Weaver Consultants Group

July 5, 2024
Project No. 0086-364-11-19

Re: Response to Comments
Tier III Permit Modification
Muskogee Community Recycling and Disposal Facility – Permit No. 3551020
Muskogee County, Oklahoma

DRAWING 6

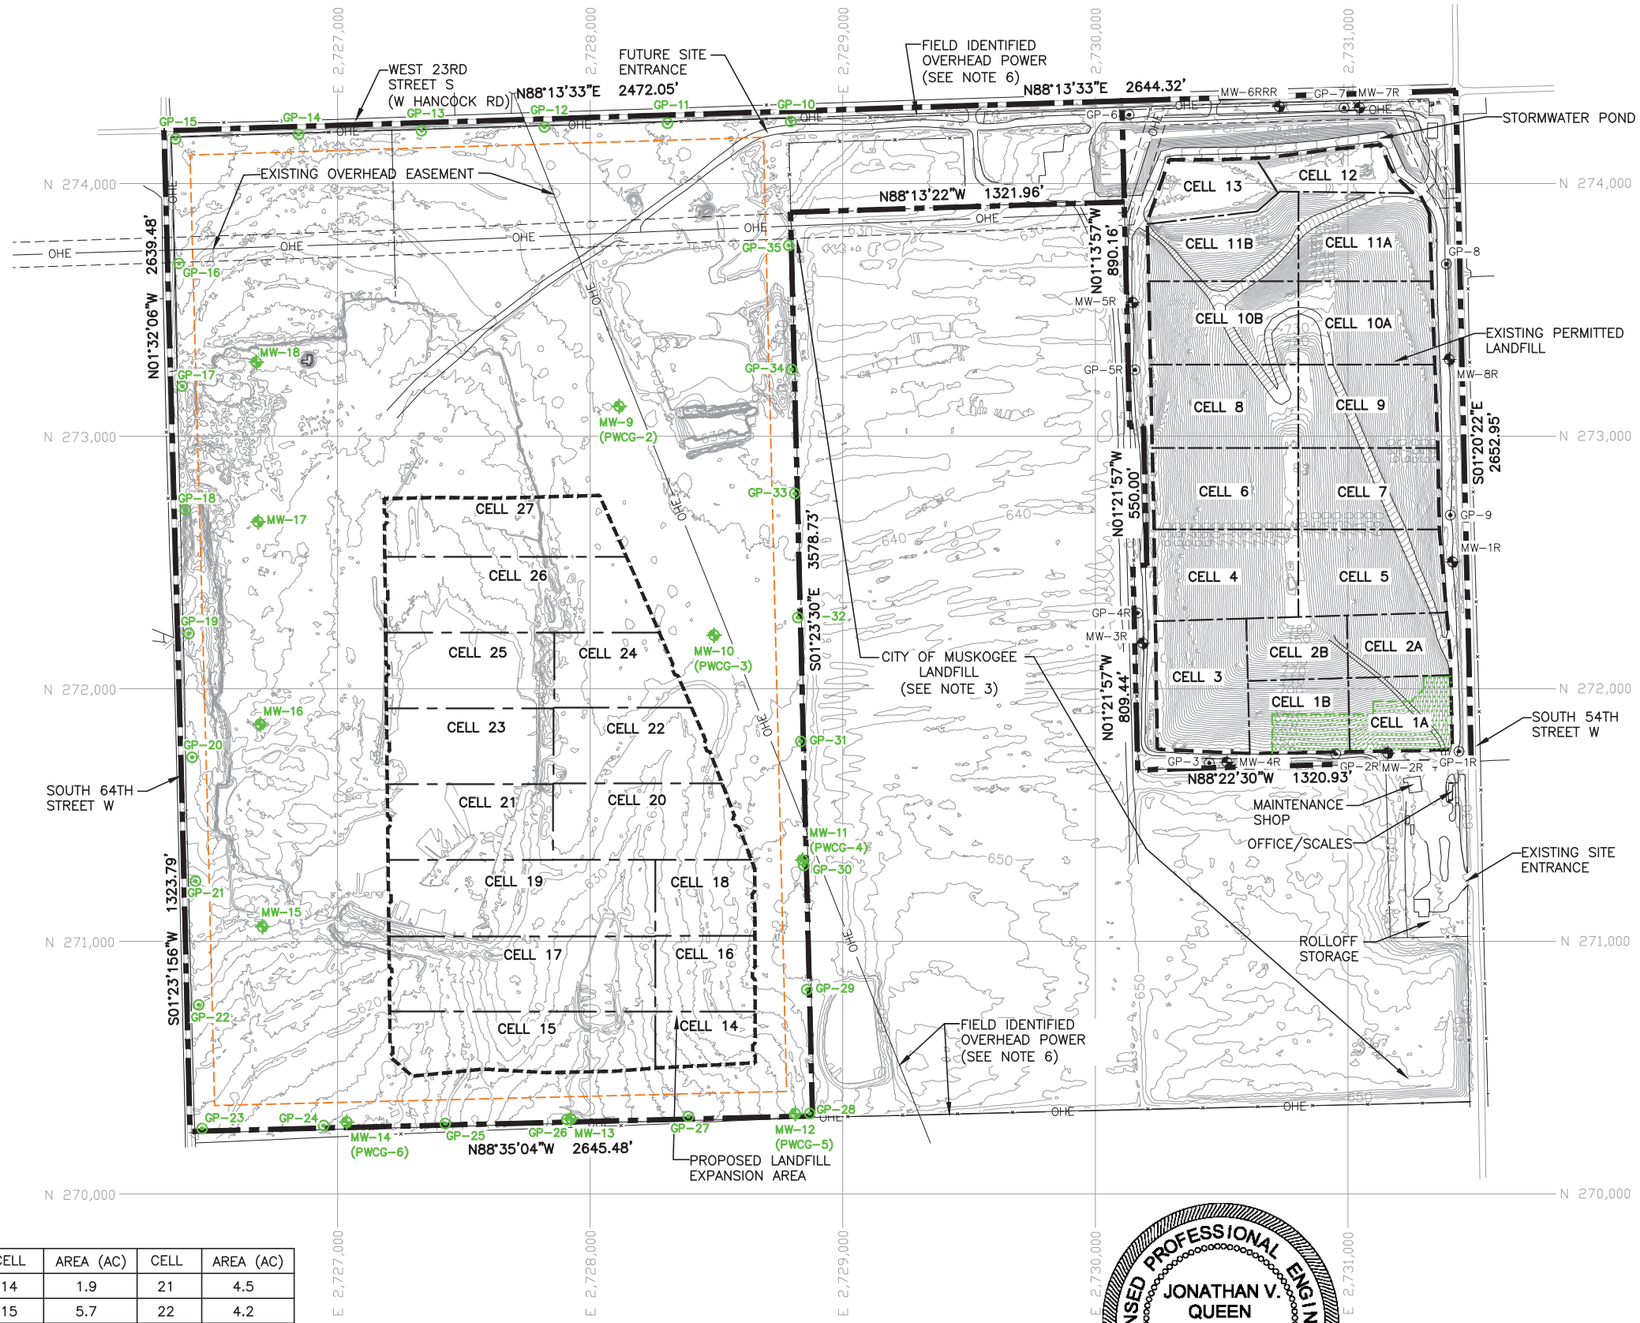
c. Site Map – The Site Plan (Drawing 6) in Volume 1 of the Application mentions the buffer zone in Note 5; however, the buffer zone is not shown on the map. In accordance with OAC 252:515-3-56(b)(3), please revise Drawing 6 to depict the buffer zone on the map.

Drawing 6 – Site Plan in Volume 1 has been revised to show the buffer zone.

DRAWING 10

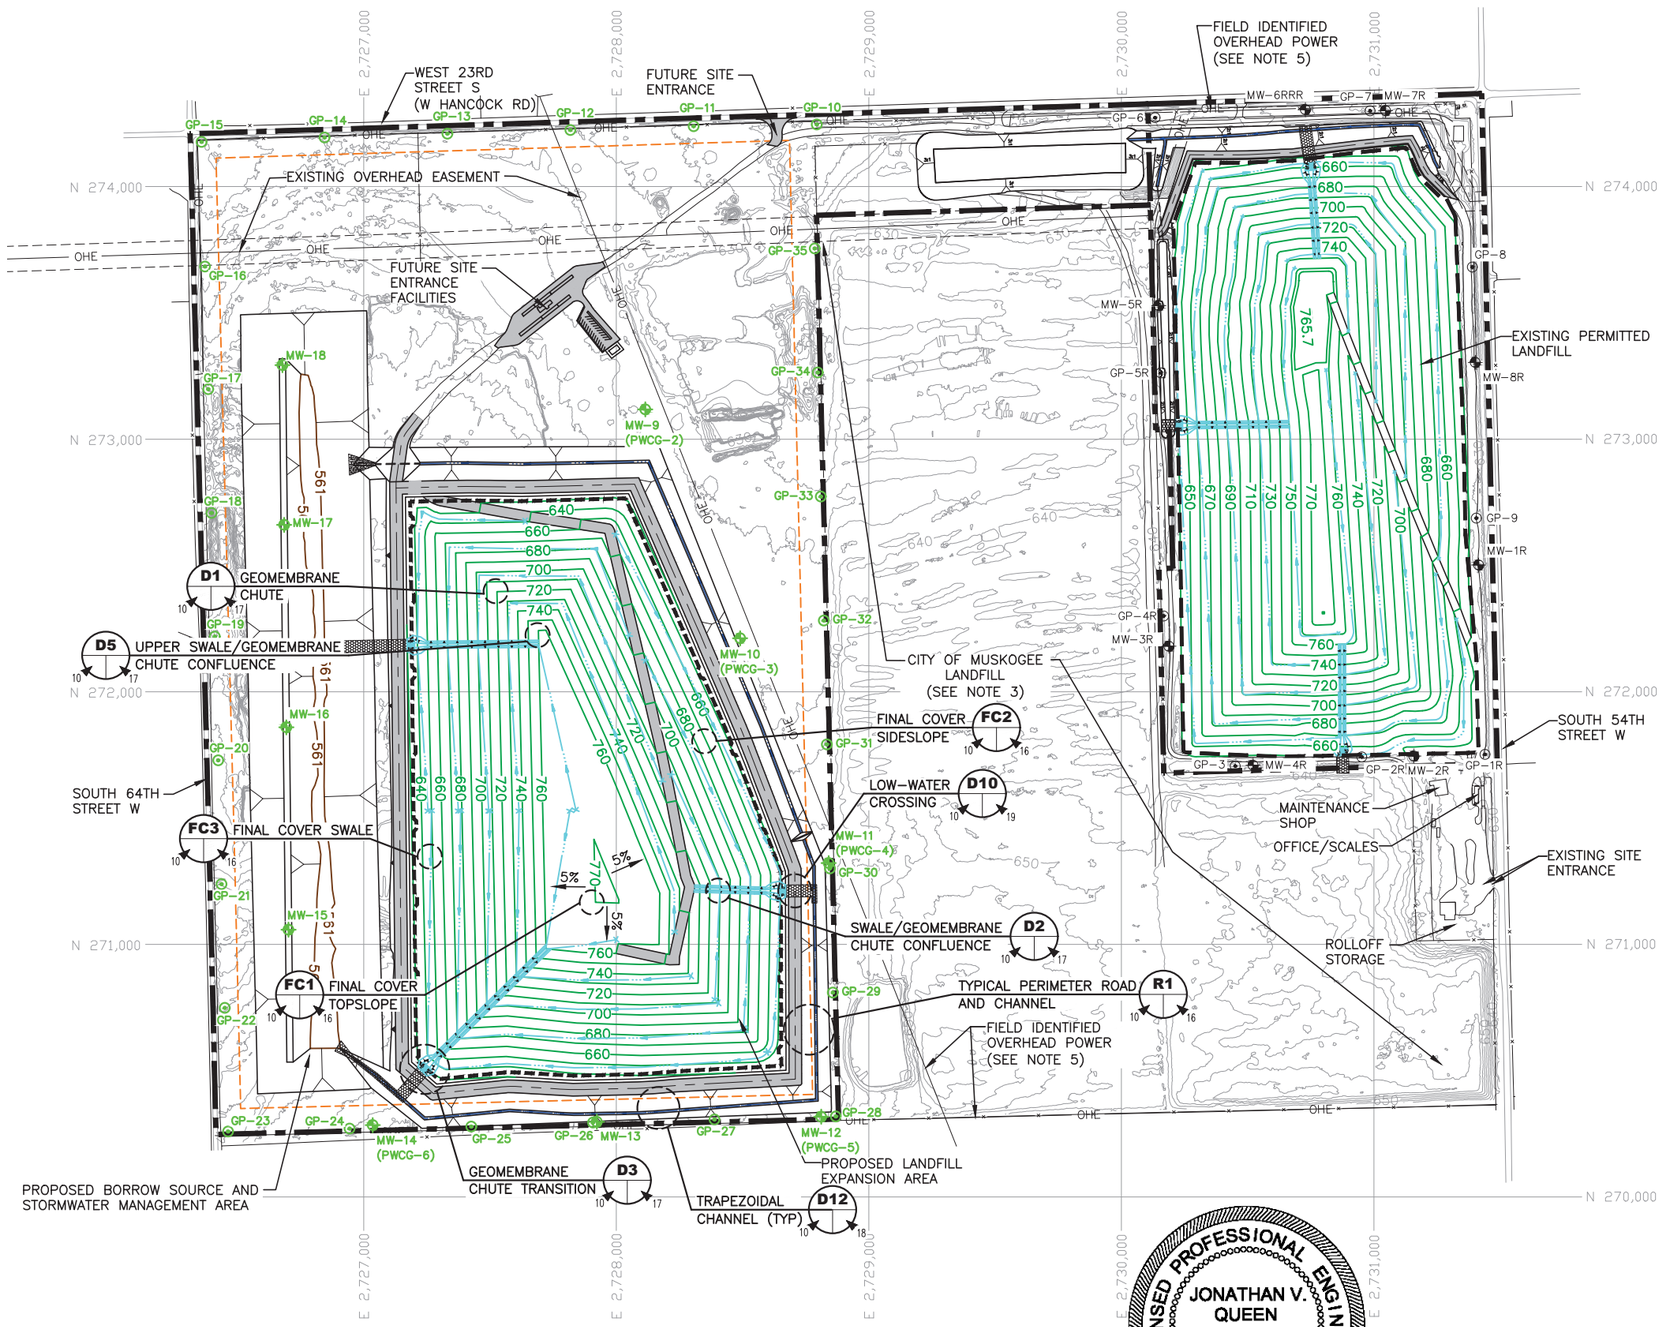
h. Completion Map – The Closure Contour and Stormwater Management Plan (Drawing 10) in Volume 1 of the Application does not include the buffer zone. In accordance with OAC 252:515-3-80(b), please revise Drawing 10 to depict the buffer zone.

Drawing 10 – Closure Contour and Stormwater Management Plan has been revised to depict the buffer zone.

DRAWING 13

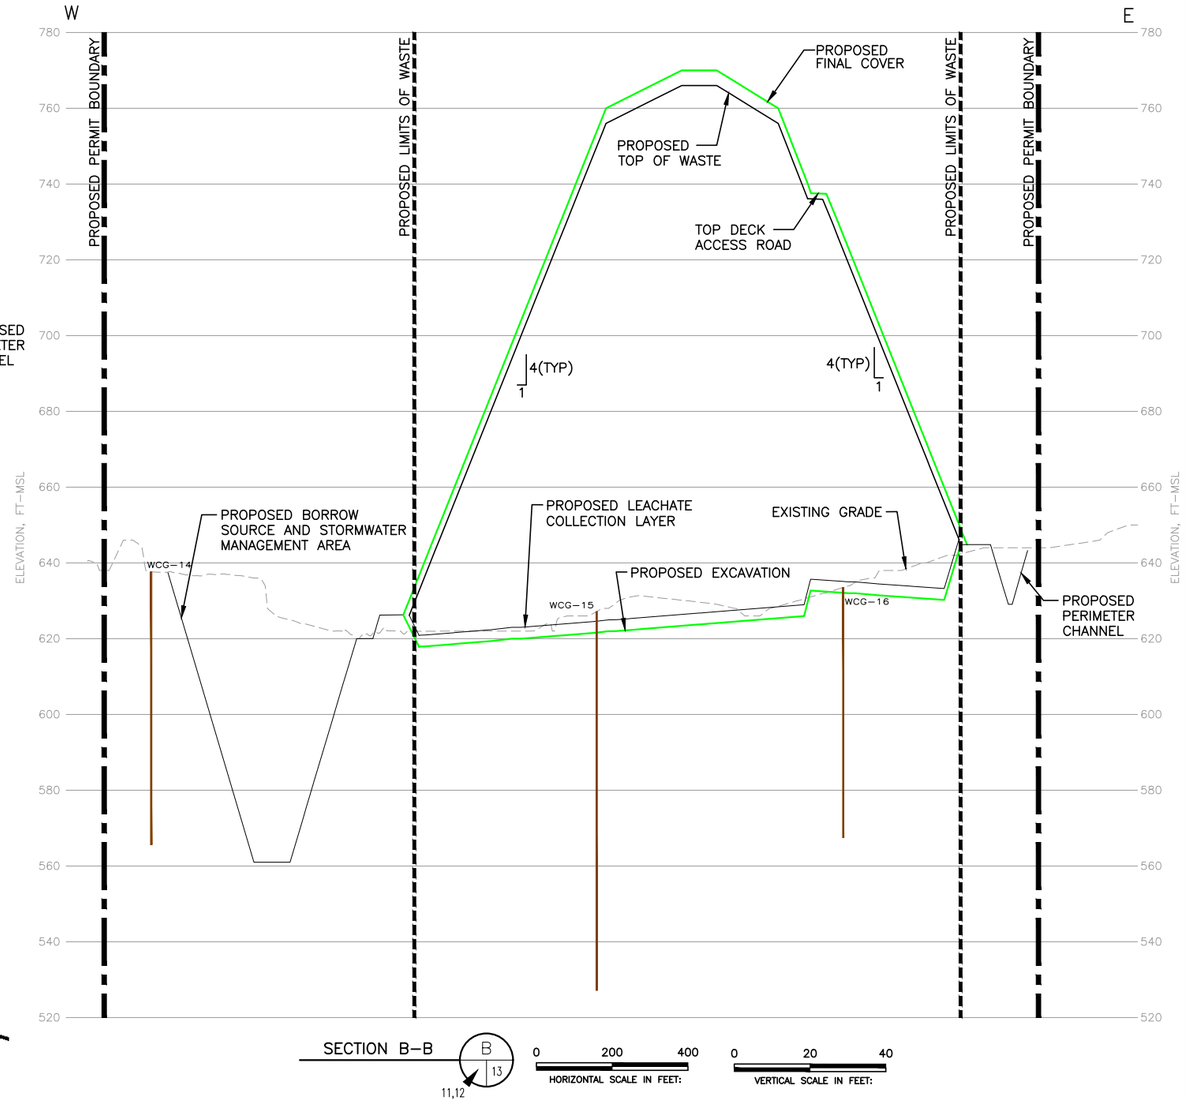
g. Fill Cross Section Map – Cross-Sections A and B (Drawing 13) in Volume 1 of the Application mentions in Note 7 that groundwater information is provided in Appendix E; however, initial and static water levels are not depicted in the drawing. In accordance with OAC 252:515-3-77(2), please revise Drawing 13 to depict the recorded initial and static water levels.

Drawing 13 (Cross-Sections A and B) has been updated to include initial and static potentiometric head groundwater elevations for the boreholes depicted. Please note that with the exception of WCG-19, no groundwater was observed in the borings illustrated in Drawing 13.

ATTACHMENT E-1-8C

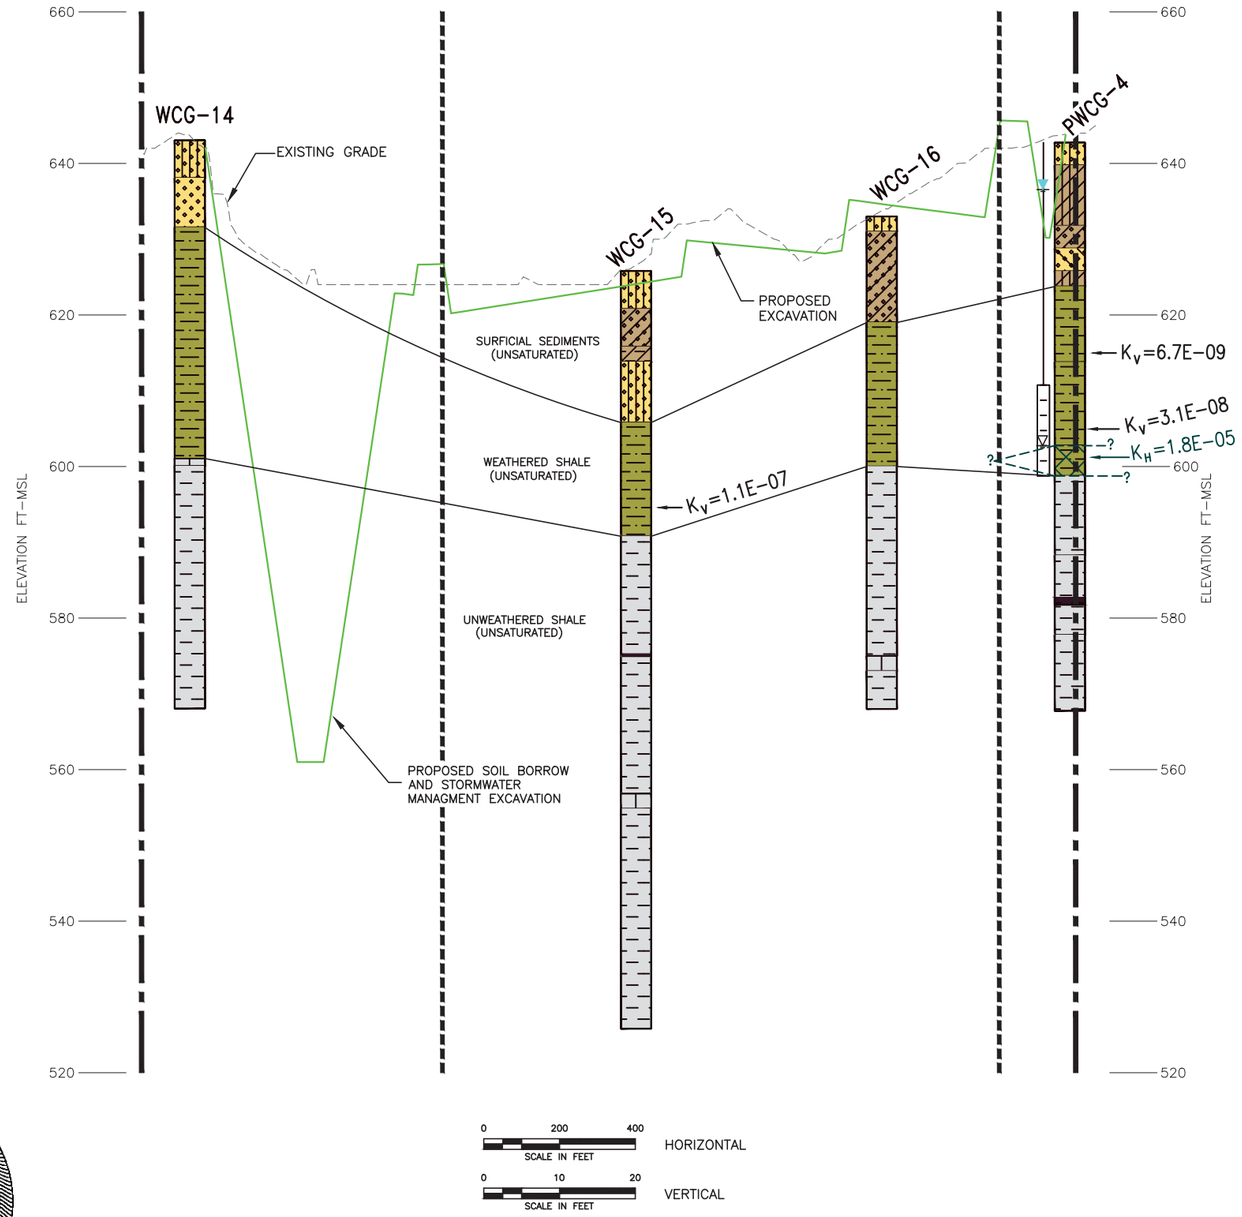
e. Geologic Cross Section Maps – The Geologic Cross-Sections (Attachments E-1-8B through E-1-8D) in Appendix E, Volume 2A of the Application depict geologic cross sections; however, the East and West axes are mislabeled. Please revise the axes in Attachments E-1-8B through E-1-8D to accurately reflect the cross-section orientation.

The Geologic Cross-Sections (Attachments E-1-8B through E-1-8D) axes have been revised to accurately reflect the cross-section orientation.

ATTACHMENT E-1-12

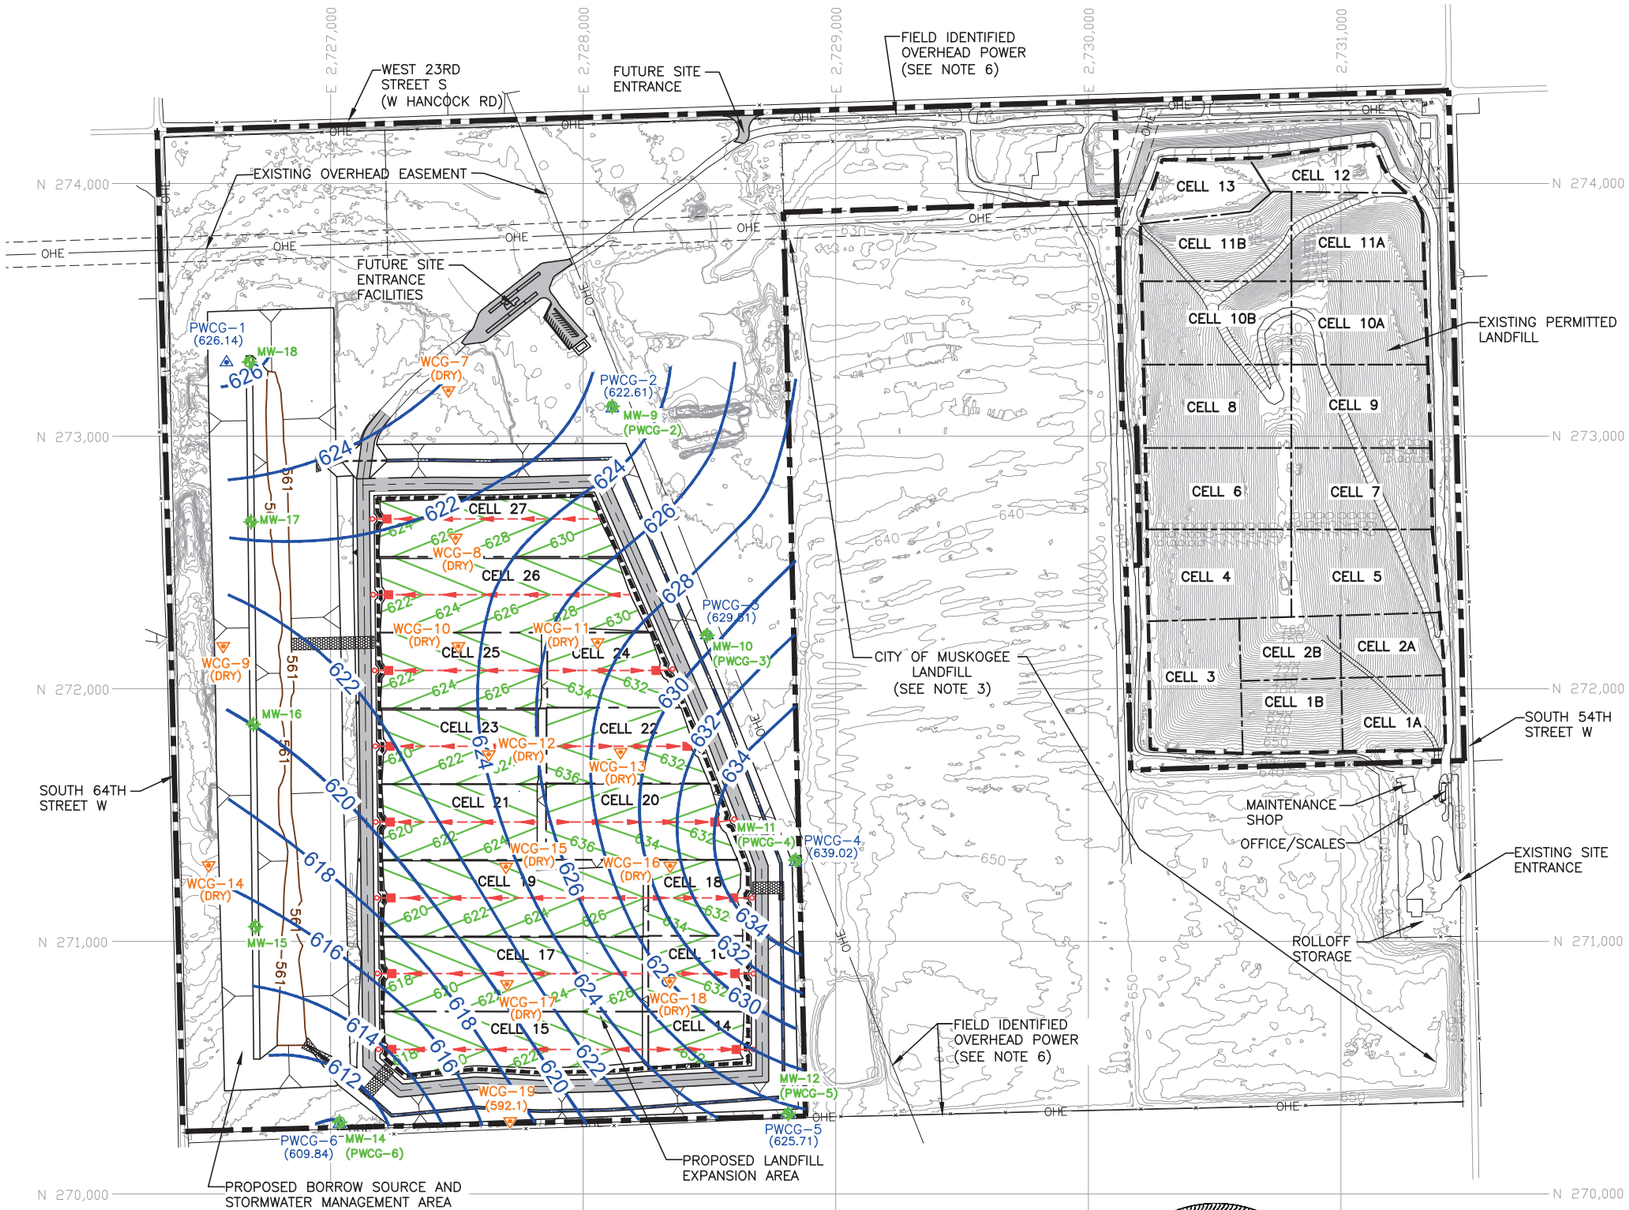
i. The Highest Measured Groundwater Potentiometric Head Surface Contour Map (Attachment E-1-12), and October 2022, December 2022, April 2023, July 2023 Potentiometric Head Surface Contour Maps (Figures E-1-13A, Figure E-1-13B, Attachment E-1-13C, and Attachment E-1-13D, respectively) in Appendix E, Volume 2A of the Application depict potentiometric head surface contours at five-foot intervals. In accordance with OAC 252:515-3-75(b)(1), please revise these figures and attachments to depict groundwater elevation contours at two-foot intervals.

ii. The Highest Measured Groundwater Potentiometric Head Surface Contour Map (Attachment E-1-12) in Appendix E, Volume 2A of the Application does not include all necessary details. In accordance with OAC 252:515-3-75(b)(2) please revise Attachment E-1-12 to depict the locations of all proposed monitoring wells, boreholes, and piezometers, and the surface elevations of each.

Figures E-1-12 through E-1-13D in Appendix E of Volume 2A have been revised to depict groundwater elevation contours at two-foot intervals.

The highest measured Groundwater Potentiometric Head Surface Contour Map (Attachment E-1-12) in Appendix E, Volume 2A has been revised to depict the locations of all proposed monitoring wells, boreholes, and piezometers, and the surface elevations of each.
